**L-612 STUDENT SERVICES CENTER REMODEL COLLEGE COMPLEX**  
 BID DOCUMENTS

drawing title:  
**SS3 LOWER LEVEL DEMO PLAN - MECHANICAL**

M-0.1	MECHANICAL SYMBOL LIST & GENERAL NOTES
M-0.2	TITLE 24 - ENERGY COMPLIANCE FORMS
M-0.3	TITLE 24 - ENERGY COMPLIANCE FORMS
M-0.4	TITLE 24 - ENERGY COMPLIANCE FORMS
M-0.5	TITLE 24 - ENERGY COMPLIANCE FORMS
MD-1.1	SS3 LOWER LEVEL DEMO PLAN - MECHANICAL
MD-1.2	SS4 UPPER LEVEL DEMO PLAN - MECHANICAL
MD-1.3	ROOF DEMOLITION PLAN - MECHANICAL
M-2.1A	SS3 LOWER LEVEL FLOOR PLAN - HVAC DUCTWORK
M-2.1B	SS3 LOWER LVL. FLR PLAN - HVAC REHEAT PIPING
M-2.2A	SS4 UPPER LEVEL FLOOR PLAN - HVAC DUCTWORK
M-2.2B	SS4 UPPER LVL. FLR PLAN - HVAC REHEAT PIPING
M-2.3	ROOF PLAN - MECHANICAL
M-3.1	MECHANICAL DETAILS
M-3.2	MECHANICAL DETAILS
M-3.3	MECHANICAL DETAILS
M-4.1	MECHANICAL SCHEDULES
M-4.2	MECHANICAL SCHEDULES
M-5.1	HYDRONIC PIPING DIAGRAM
M-5.2	AIR FLOW DIAGRAM
M-6.1	MECHANICAL CONTROL DIAGRAM
M-6.2	MECHANICAL CONTROL DIAGRAM
M-6.3	MECHANICAL CONTROL DIAGRAM

**1 CHILLED WATER AND HEATING HOT WATER FLOW DIAGRAM**  
NO SCALE

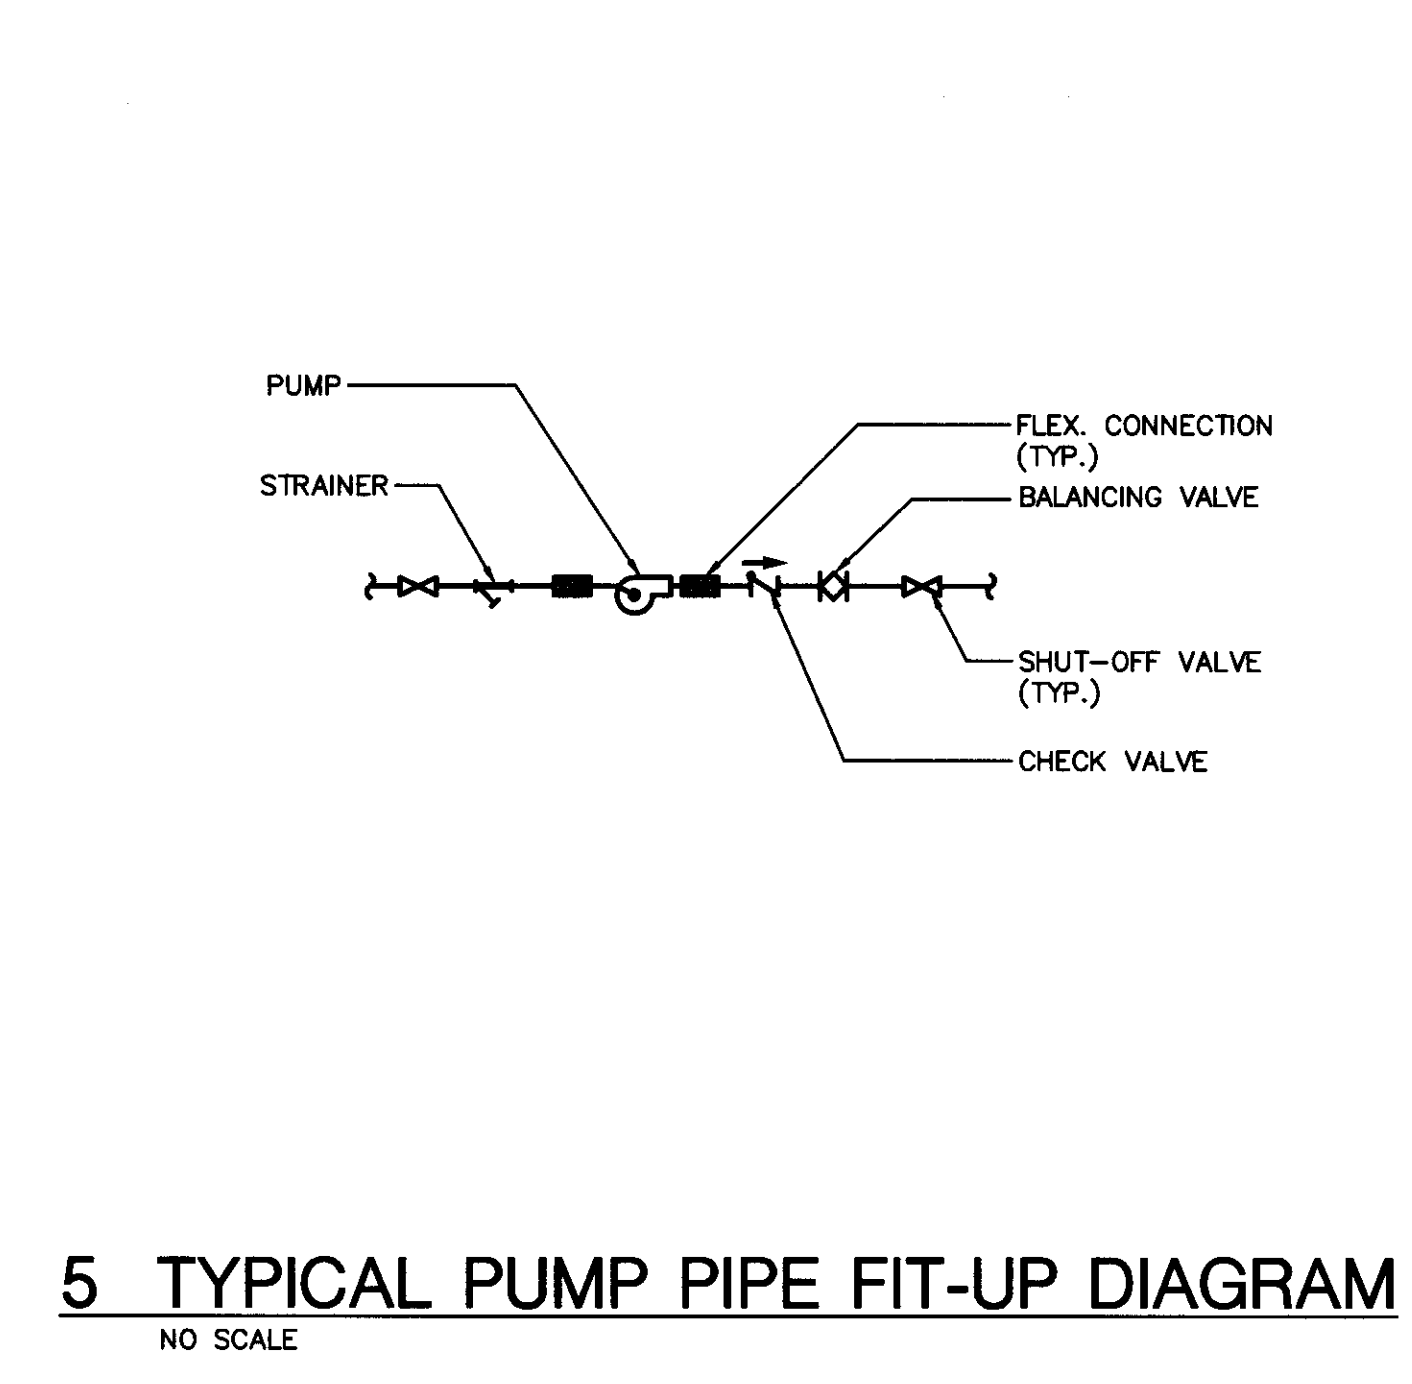
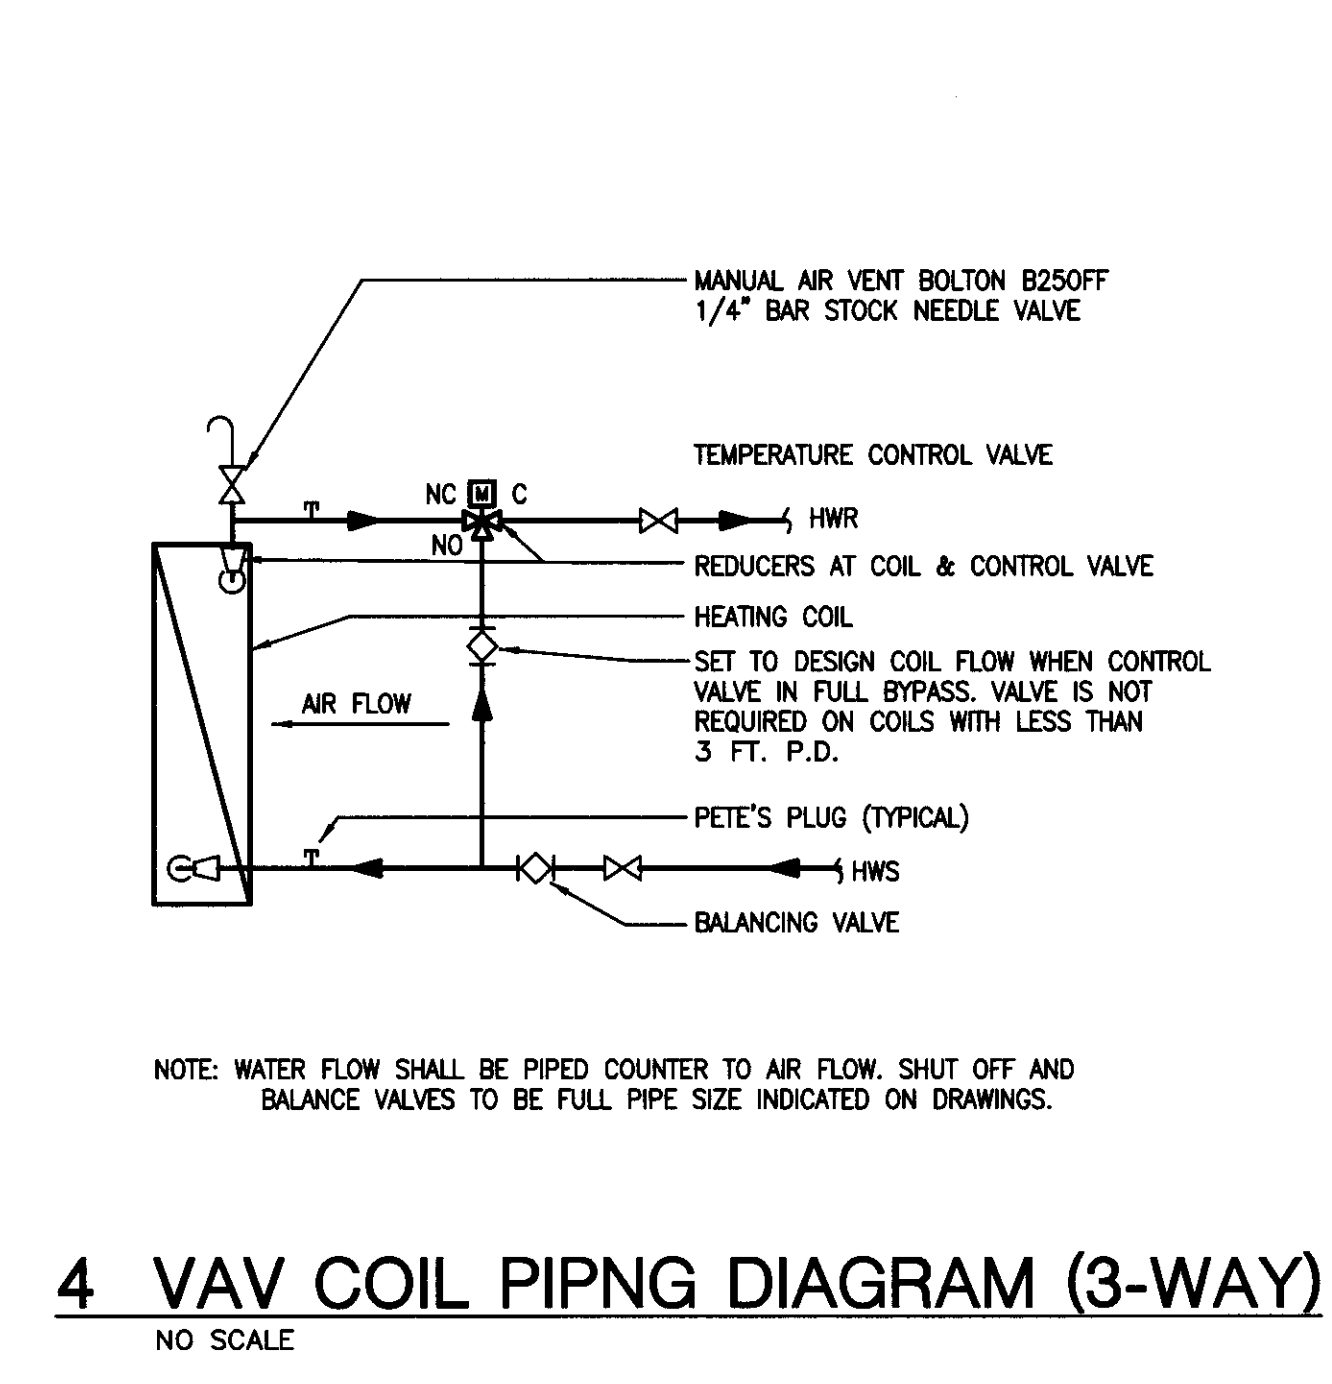
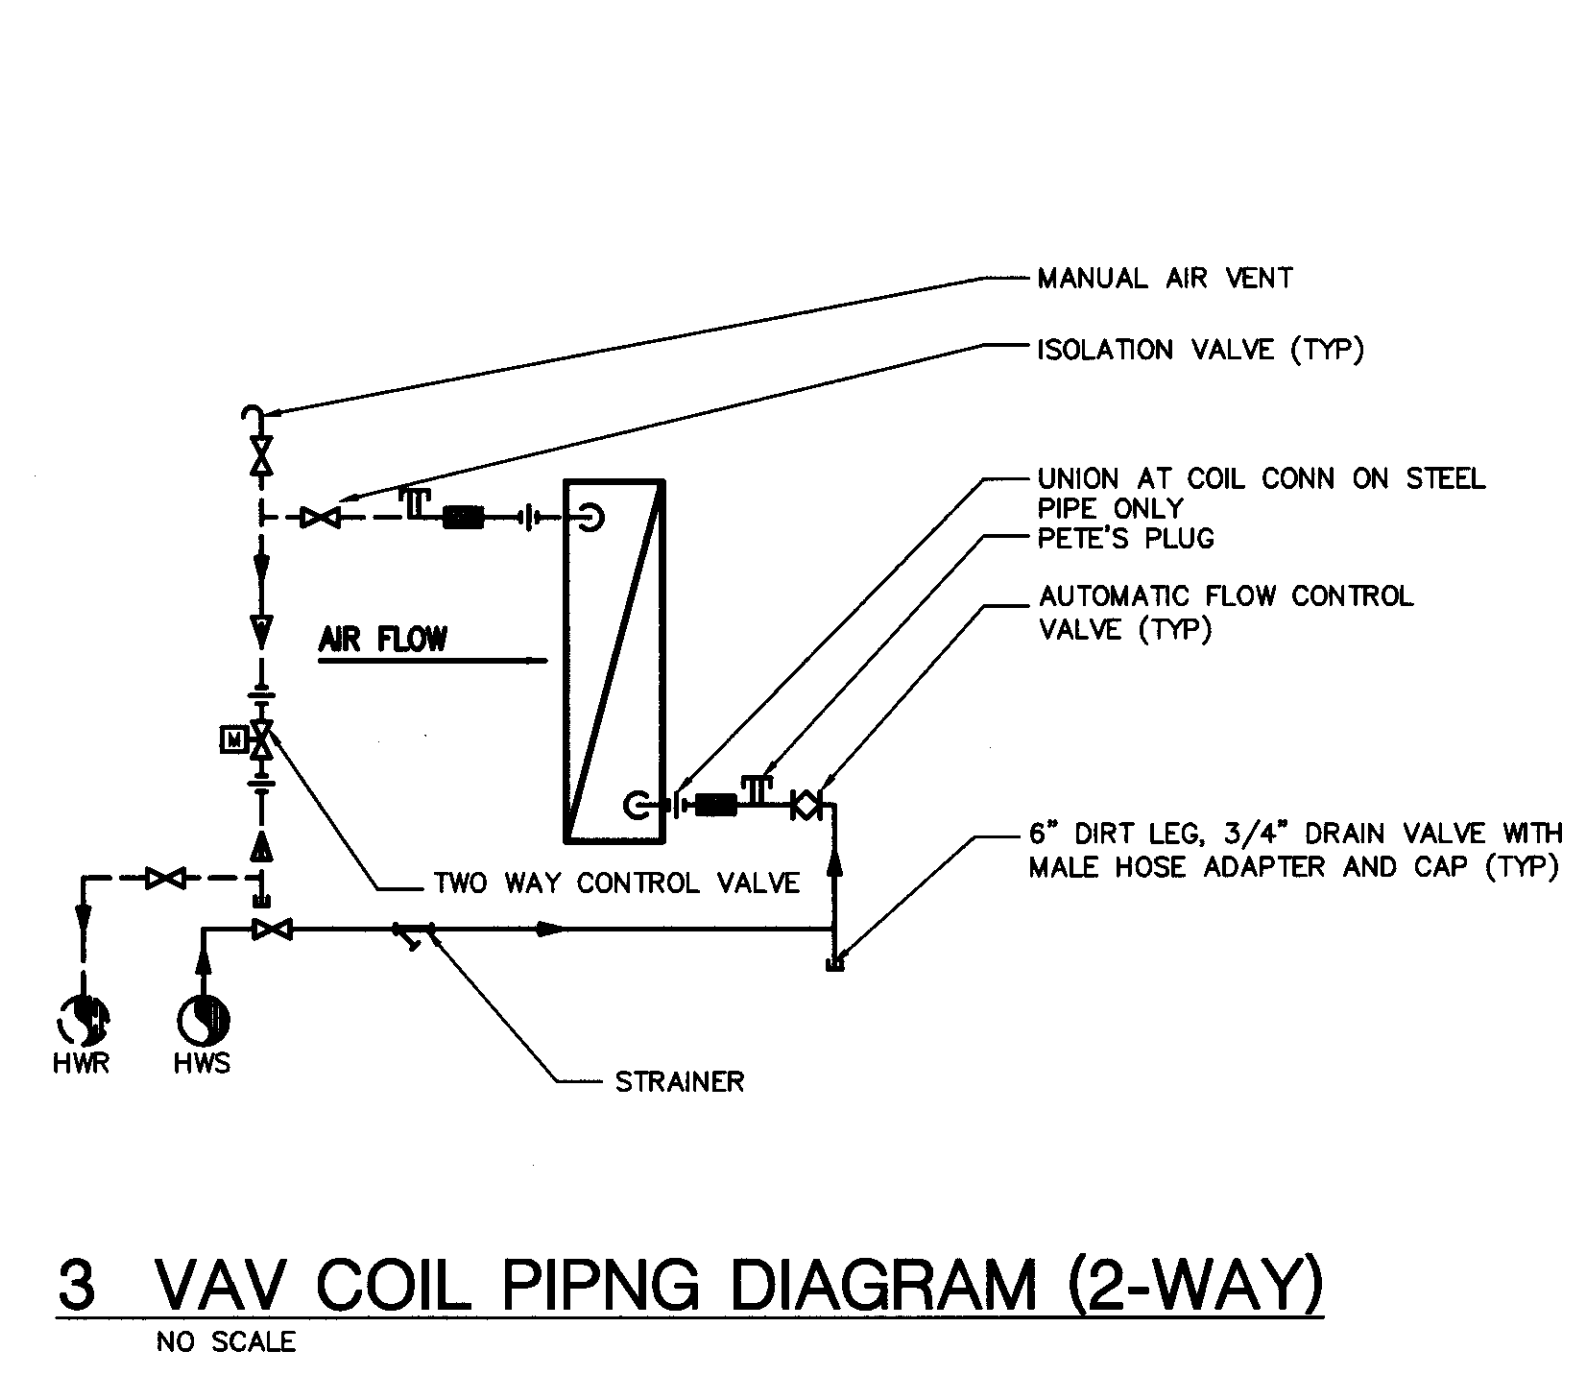
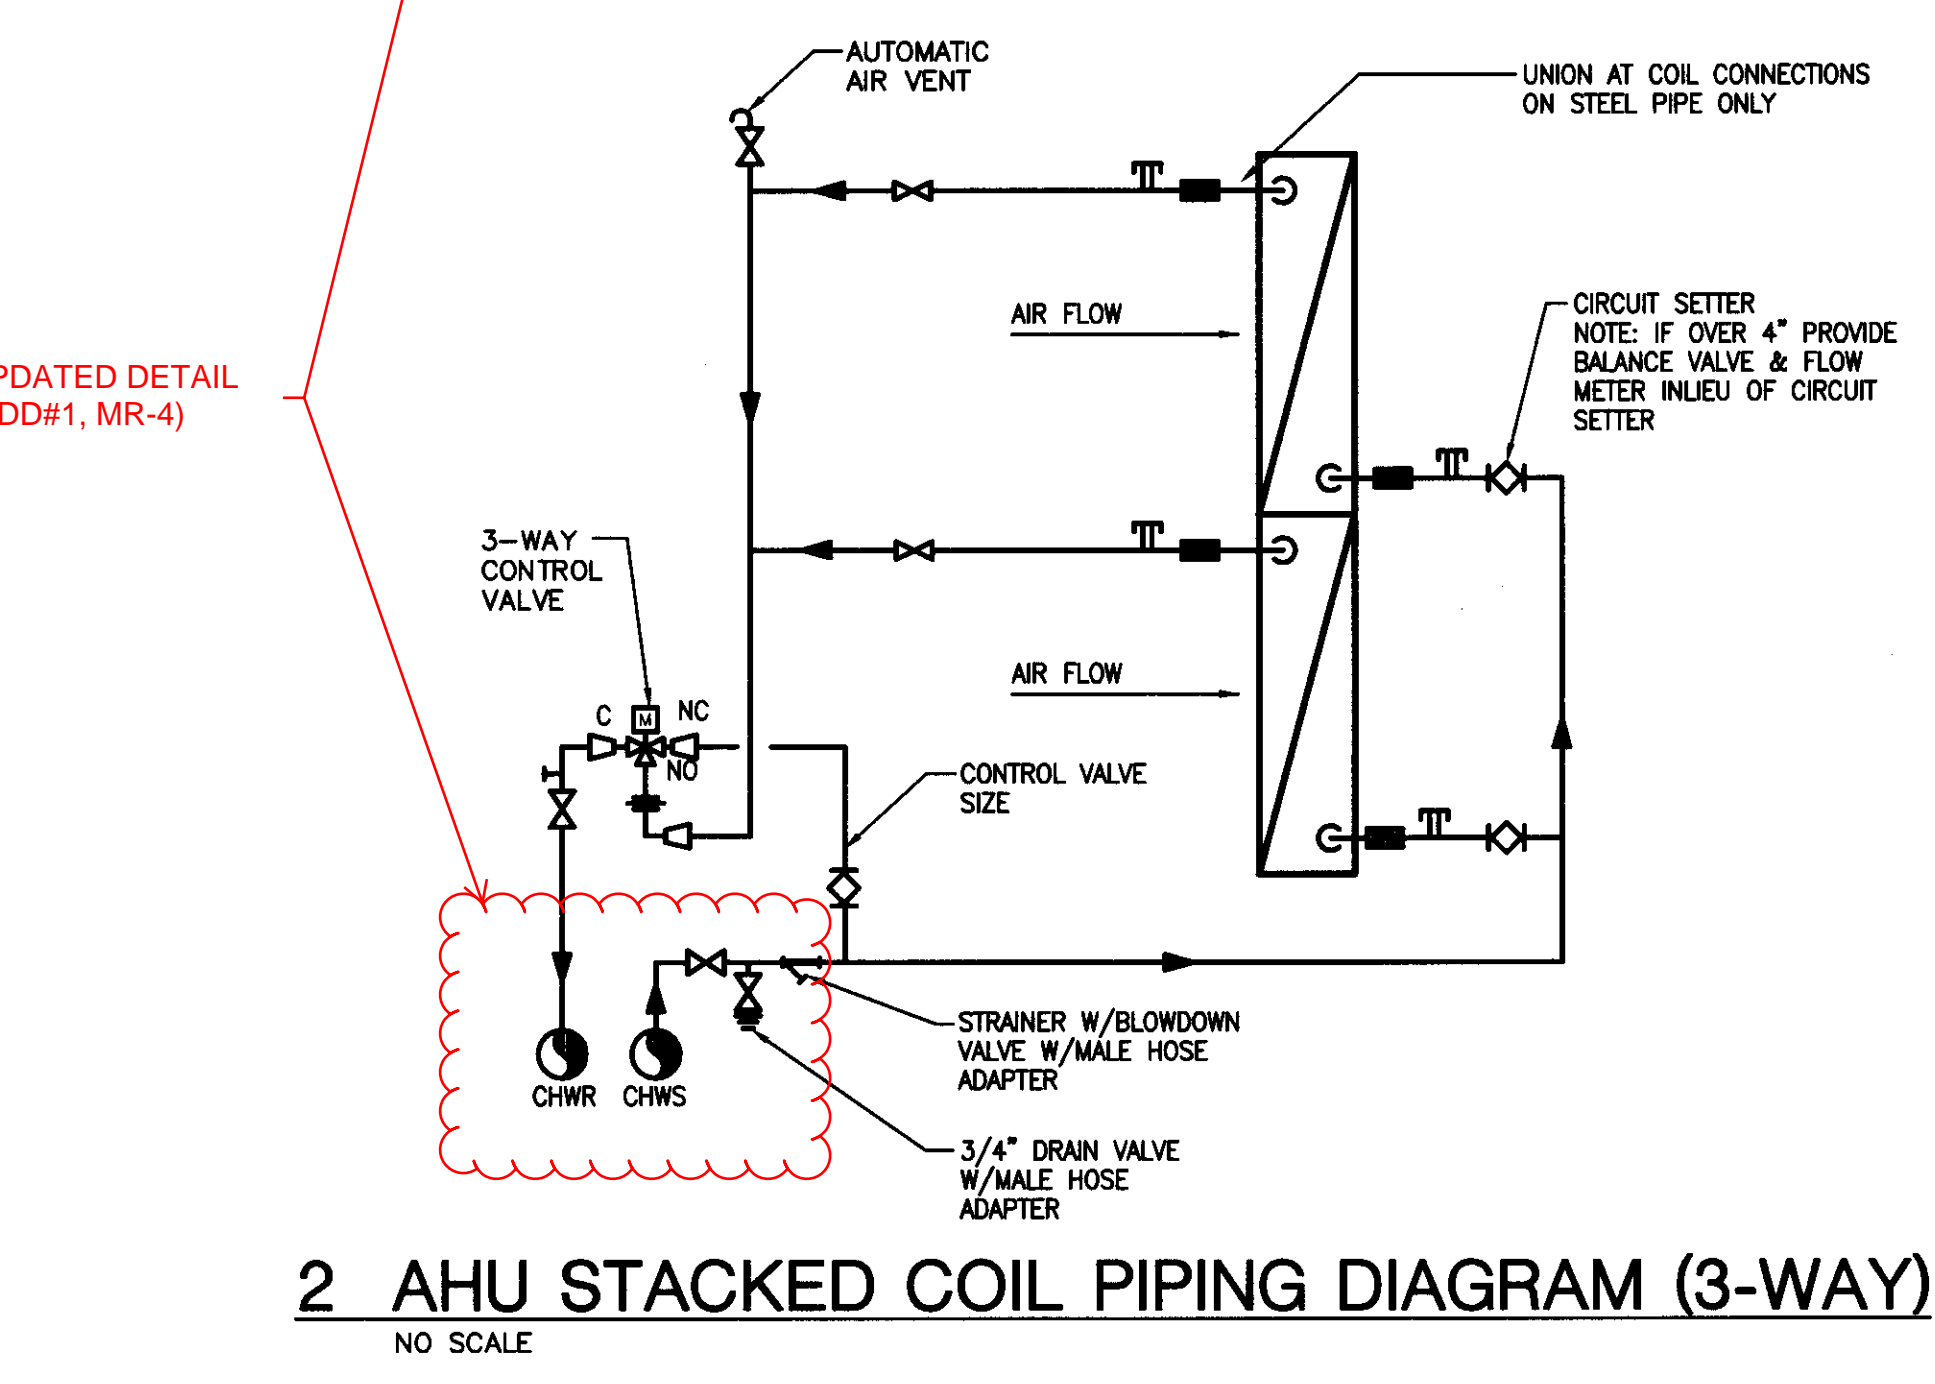
UPDATED DETAIL (ADD#1, MR-4)

- 1 QTY. OF FANS DIFFERS PER AIR HANDLER (AHU). SEE AHU SCHEDULES FOR NUMBER OF FANS. POINTS SHOWN ARE PER FAN.
- RFI 184 - CONFIRM 3-WAY VALVES FOR CHW AND HHW COIL PIPES AS SHOWN ON DETAIL 1-M-5.1

tBP project number: 200810.00  
file name: 0106M62.dwg  
drawn by: GE checked by: BC  
date: JULY 31, 2012  
Rev. date: description:  
drawing title: MECHANICAL CONTROL DIAGRAM  
drawing no: M-6.2 drawing of

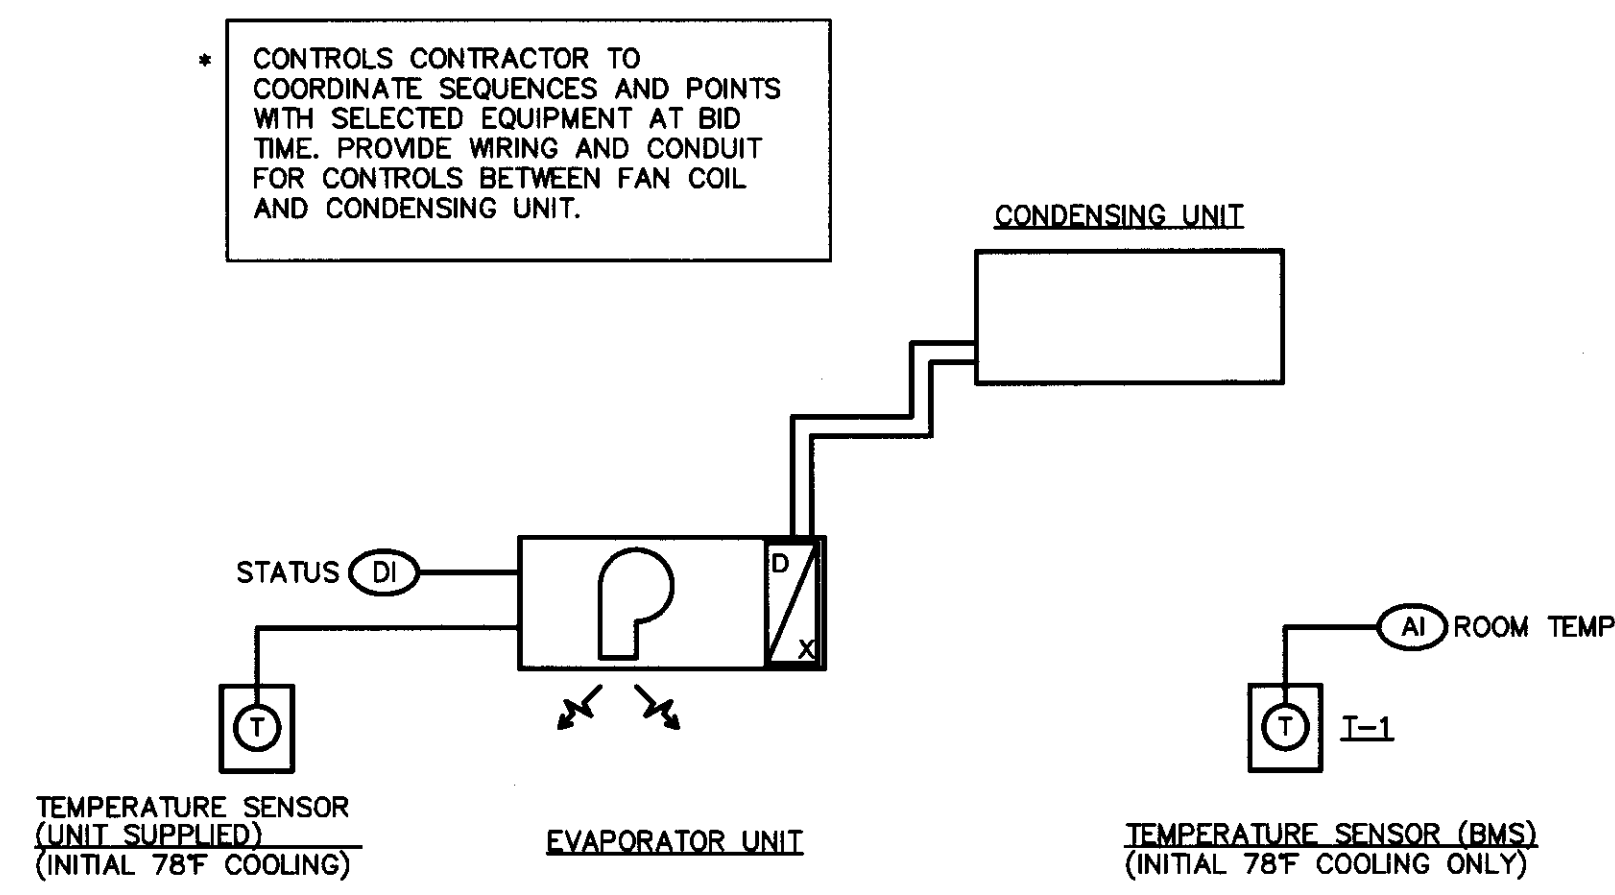
RFI 233 - CONFIRM 2/M-6.2 SHOULD BE FOLLOW
